Peer Review of Alligator and Whites Creek Flood Modelling and Mapping

Reference: R.A10416.002.00_Alligator_Whites_Creek_Review.docx
Date: February 2021
Confidential

This peer review report documents the review findings for the modelling contract undertaken for the **Alligator Creek and Whites Creek** catchments by Northern Consulting Engineers (NCE).

Figure 4-1 Glasswalling in downstream area (1% AEP event)

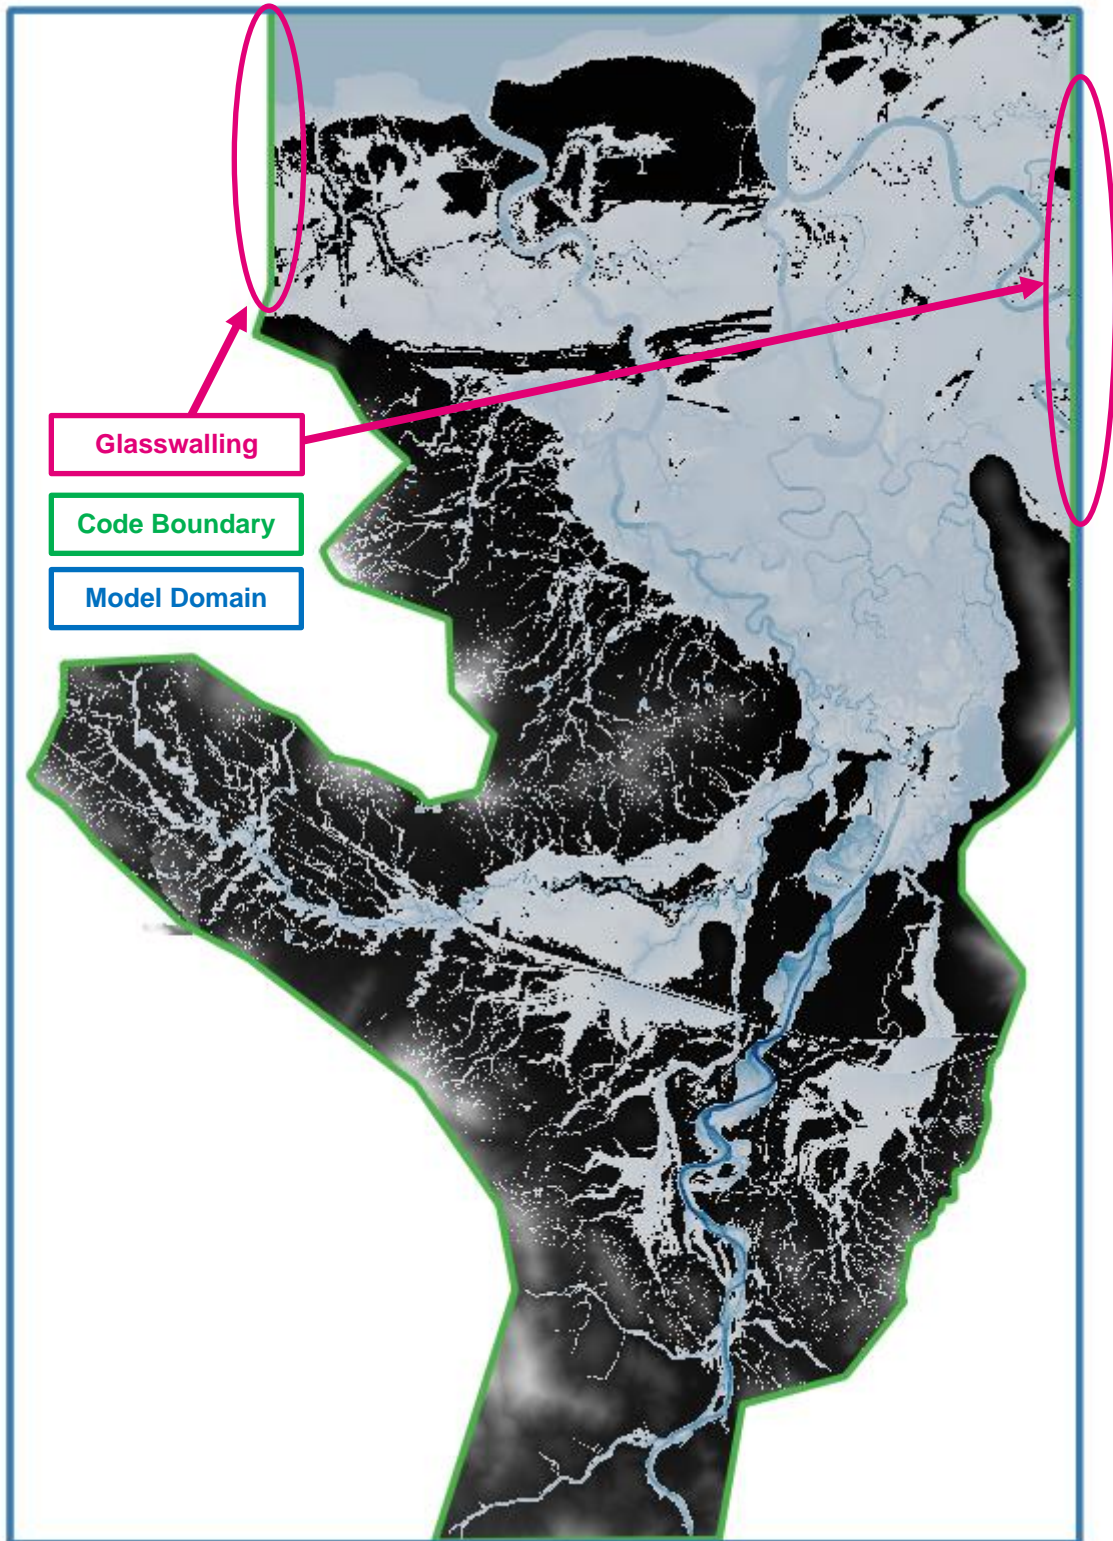
ID	BMT Observation	BMT Recommendation
4.2.3.1	<p>Code and orientation: The domain extent and orientation are reasonable in relation to active code area - there is not significant redundant area included that may impact on memory requirements. The active code extent is generally appropriate, with the upstream subcatchments trimmed to only capture the downstream end where the source area and external QT inflows are applied. The entire subcatchments are included in the active code extent where direct rainfall is applied.</p> <p>However, the extents of the code boundary along the east and west sides of the downstream areas cause 'glasswalling' of water, as shown in Figure 4-1 below this table. The sides of the active code here are not connected to open boundary cells. It is recognised that these areas of glasswalling are limited to the tidal/estuary zones, well downstream of the area of interest, and that assumptions such as this are likely necessary. The eastern downstream area is one of particular uncertainty, due to the likely interactions with Crocodile Creek that would occur in reality, which has been excluded from consideration in this modelling.</p> <p>There is minor area of glasswalling in events larger than the 0.5% AEP at subcatchment KM-1-DS. This is not expected to have a significant impact on results.</p>	<p>Glasswalling at downstream area of active code boundary. Reporting would benefit from additional detail/explanation on the model configuration in this area. It should be confirmed in the report that such areas are not specific areas of interest and that results should be treated with caution near to these affected boundaries.</p>

ID	BMT Observation	BMT Recommendation
4.5.1.4	<p>Gridded Outputs - Glass walling: As discussed in the TGC Code and Downstream boundary sections, glass walling occurs along the east and west sides of the code boundary in the downstream, where no open boundaries exist.</p>	<p>Glasswalling at downstream area of active code boundary. Reporting would benefit from additional detail/explanation on the model configuration in this area. It should be confirmed in the report that such areas are not specific areas of interest and that results should be treated with caution near to these affected boundaries.</p>

Figure 4-2 Incongruent elevations between boundary of 2009 and 2016 LiDAR datasets

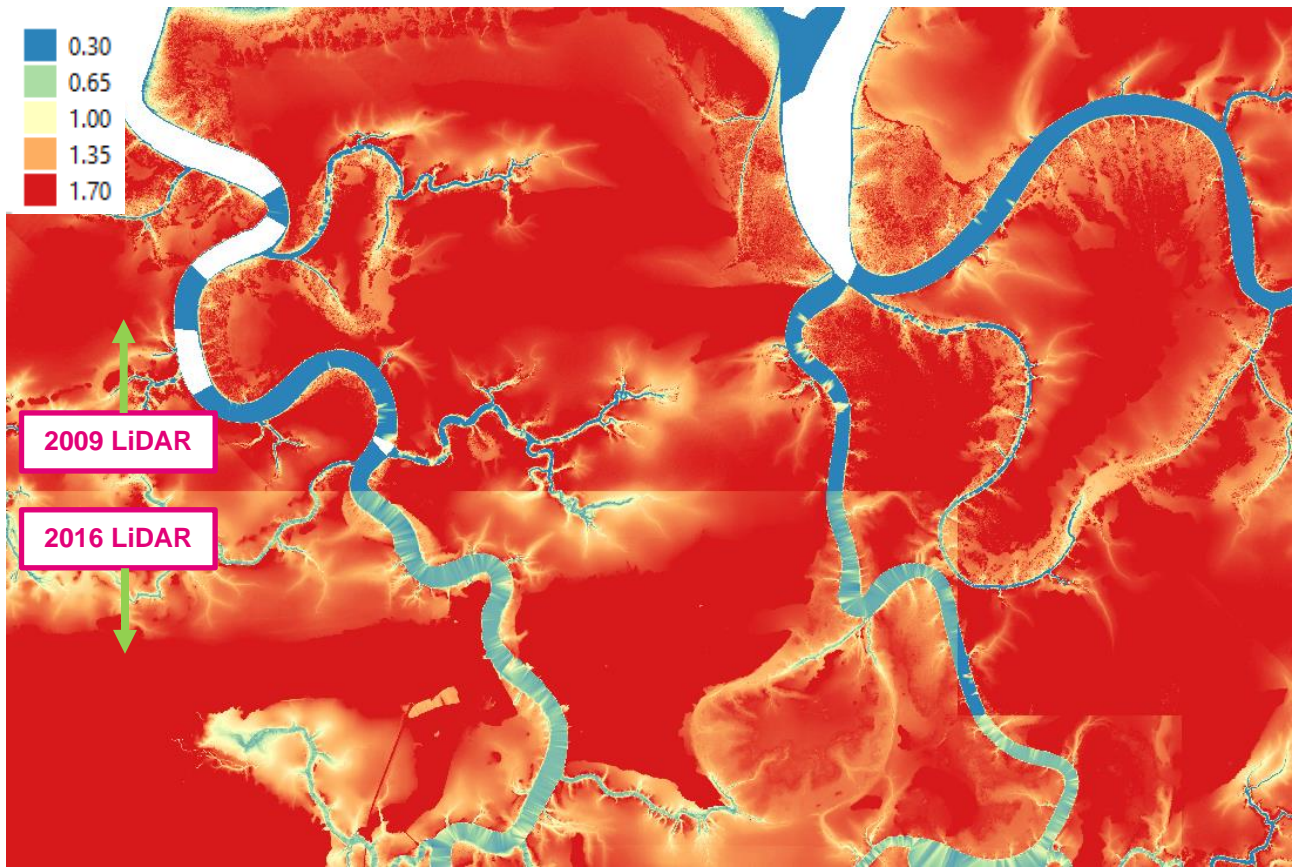
4.2.3.4	<p>Base Topography: Three base LiDAR topographic datasets are used in the model. These appear to be layered and clipped appropriately relative to capture date. Reporting does not clearly document the metadata for the datasets, including resolution (confirmed as 1m from inspecting datasets), nor the available extent of each LiDAR source. The 2018/2019 LiDAR data has been used to represent the Elliot Springs subdivision, however it is unclear if this data may cover a wider area where it should have been used in preference to the 2016 LiDAR. If this were the case, it is unclear from reporting if the 2016 LiDAR was comparable to the 2018/2019 LiDAR elsewhere, or if there was other justification for limiting its extent of application or comparison provided.</p> <p>The clipped extents of the 2018/2019 LiDAR included in the model was confirmed to merge well with the underlying 2016 LiDAR. However, the join between the 2016 and 2009 LiDAR datasets in the downstream extent of the model did not show good agreement, as demonstrated in Figure 4-2, below this table. The 2009 LiDAR is generally higher across the floodplain areas, and the watercourse channels are generally lower (likely due to the data capture at different tide levels). This may create a minor damming effect at low water levels.</p> <p>The LiDAR also has poor triangulation across the channels in the downstream area, and as it picks up the tidal level at the time of capture, many creeks are represented with topography that is higher than set IWLs and boundary conditions. It is recognised that these areas are still likely controlled by the downstream boundary conditions and don't affect the main area of interest up Alligator and Whites creeks (as evident from the results of the Joint Probability assessment). For the climate change and joint probability scenarios, the initial water level is set at an elevation that submerges these poorly merged areas.</p>	<p>Generally appropriate.</p> <p>Reporting would benefit from specifying metadata for the input LiDAR datasets, including resolution, and clarification of the available data extents and choices in clipping them. Topographic edits could be made to merge the different datasets together more smoothly and eliminate triangulation issues in the LiDAR, particularly in the creek channels but ultimately this is unlikely to affect project outcomes given the downstream location.</p> <p>Similar to the glasswalling comment for ID 4.2.3.1, a general limitation should be given on the accuracy of results in this downstream area. This would also apply to smaller modelled events where limitations of having no bathymetry would have a greater influence.</p>

4.2.3.9	<p>Bathymetry: The model does not include any representation of bathymetry. It is recognised that this data may not exist. However, it is noted that the different base LiDAR topography datasets pick up different tidal water levels (due to time of capture) in the downstream sections (with some sudden step changes) and there is uneven triangulation across the downstream extents of Alligator Creek and the estuaries. Some areas of creek channels are set to a higher "ground" elevation than some of the initial water levels set for different scenarios.</p>	Reporting would benefit from discussion on the necessity (or lack thereof) for inclusion of data or assumptions about bathymetry. The impact of not including bathymetry is unknown but is potentially not significant for larger events that are largely out of bank. It may have a greater impact on smaller events however.

Figure 4-3 Example of direct rainfall causing misrepresented flowpaths in neighbouring source-area-represented catchments

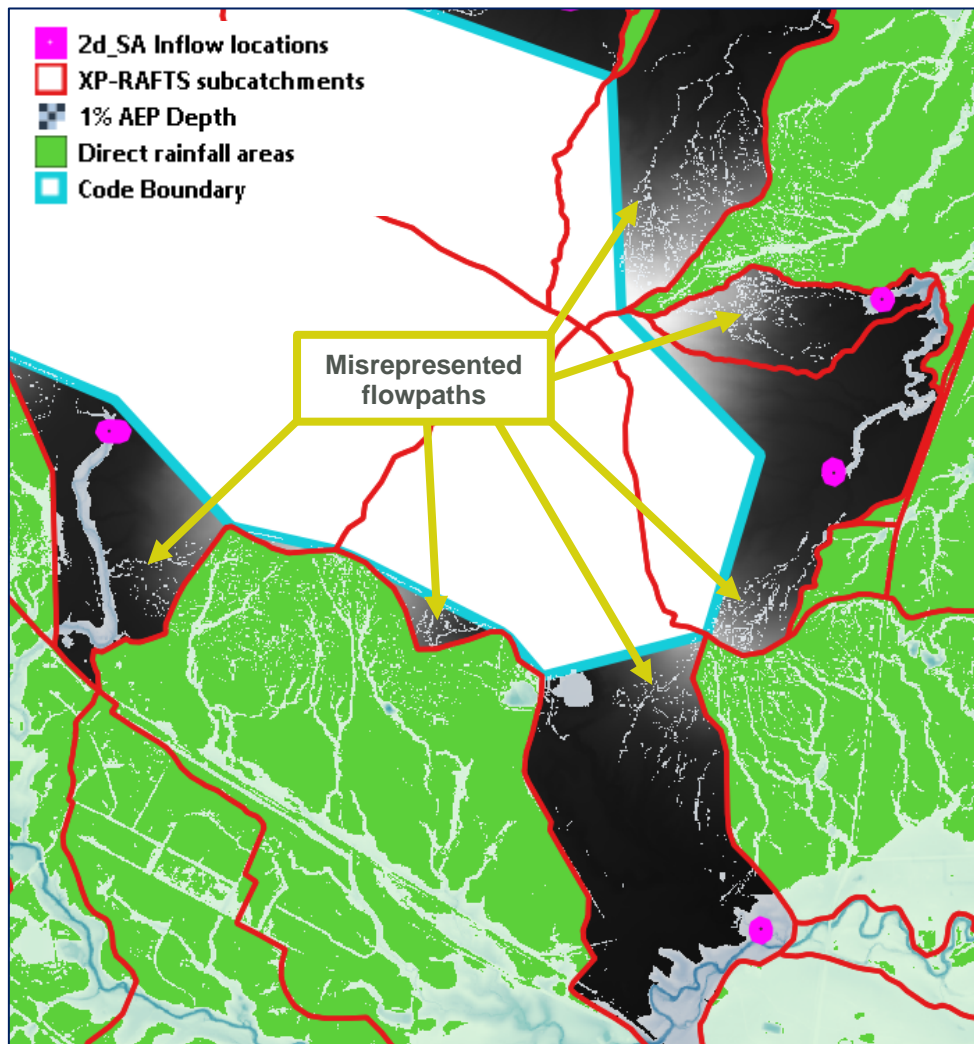
ID	BMT Observation	BMT Recommendation
4.2.6.4	<p>Direct Rainfall Inflows: The direct rainfall inflows are applied as two separate 2d_rf polygons. The areas of application are assumed to have been agreed with TCC to appropriately cover "urban" areas, as requested in the RFQ.</p> <p>Rainfall inputs have been confirmed to be correctly linked to event and duration dependent hyetograph CSVs in the scenario-dependent bc_dbases.</p> <p>The hyetographs were confirmed to be configured with 0 values at first and last timesteps as recommended by TUFLOW.</p> <p>Reporting does not document the methodology of applying the direct rainfall boundaries, nor the relevant ARR2019 parameters. It therefore cannot be completely confirmed that the input hyetographs are correct. It appears that the same or similar data for the IFD location used in the hydrologic modelling has been used. Input hyetographs were spot checked and confirmed to have an appropriate total rainfall with areal reduction factor applied (though did not match the hydrologic model inputs exactly).</p> <p>The hyetographs for the two 2d_rf polygon sources were identical for design events, and differed based on gauged data for calibration which allows for a spatial rainfall pattern in the calibration.</p> <p>Currently, the 2d_rf polygon extents appear to use the XP-RAFTS subcatchment delineation. However, it is recommended that the 2d_rf polygons are aligned with more accurate topographic boundaries derived from LiDAR data (or be inset from the subcatchment boundaries), to ensure that they do not inadvertently extend into neighbouring catchments. Where the boundaries are not configured exactly along the crest of a subcatchment (in accordance with the base LiDAR topography), the 2d_rf polygon is sometimes being applied over model cells that drain into the neighbouring catchment. This is evident in all subcatchments bordering the 2d_rf area. These adjacent (non-direct rainfall) subcatchments then result in rainfall runoff trickling into the subcatchment and showing as a flow path in the resultant mapping, see example in Figure 4-3, below this table. These flows will not be representative of design flows and could be misinterpreted in the mapping.</p> <p>It is recommended that instances of this are either fixed by adjusting the model boundaries or appropriately caveated in the report/mapped figures.</p>	<p>Reporting requires additional detail/explanation on the application methodology and parameterisation of the direct rainfall, particularly in relation to ARR2019 compliance.</p> <p>Direct rainfall 2d_rf polygons should be aligned with more accurate lidar data (or inset from the top of catchment) to prevent minor spillage into neighbouring subcatchments. If left as is, appropriate caveats should be included in the mapping/reports.</p>

4.5.1.5	<p>Gridded Outputs - Unintended mapped flowpaths: As discussed in the TBC 2d_rf direct rainfall Section 4.2.6.</p>	<p>Recommendation as per ID 4.2.6.4</p>

- Currently, the configuration of direct rainfall 2d_rf polygons results in mapped flowpaths that are not representative of design flows in the upper reaches of adjacent (non-direct rainfall) subcatchments. The direct rainfall polygons should be aligned with more accurate LiDAR data (or inset from the top of catchment) to prevent minor spillage into neighbouring subcatchments. If left as is, appropriate caveats should be included in the mapping/reports.
